Access Compliance Report Public Rights-of-Way (Curb Ramps)

Main Street: N/A Cross Street: REATA_RD Location: NW

ADA ID: RPRK211118135123 Ramp Type: Type 1 - Perpendicular Initial Pass/Fail: Fail Overall Compliance: No Severity Score: 16

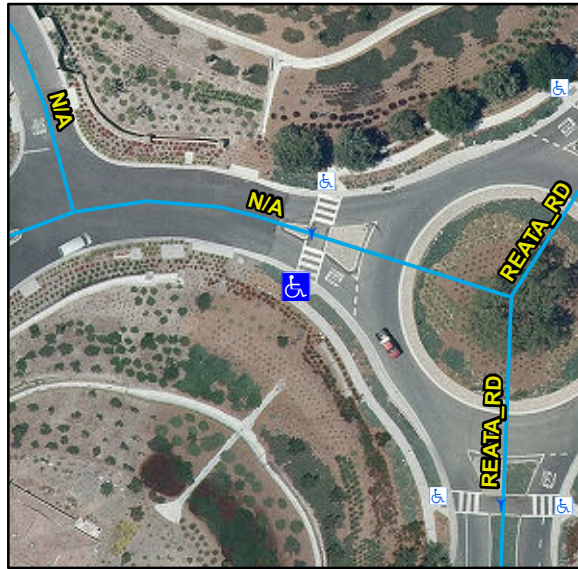
Surveyor Notes:

N/A

OC Std/PROW:

R304.2.2, R304.5.3, STD 1115

Possible Solutions:

Remove & Replace Entire Ramp.
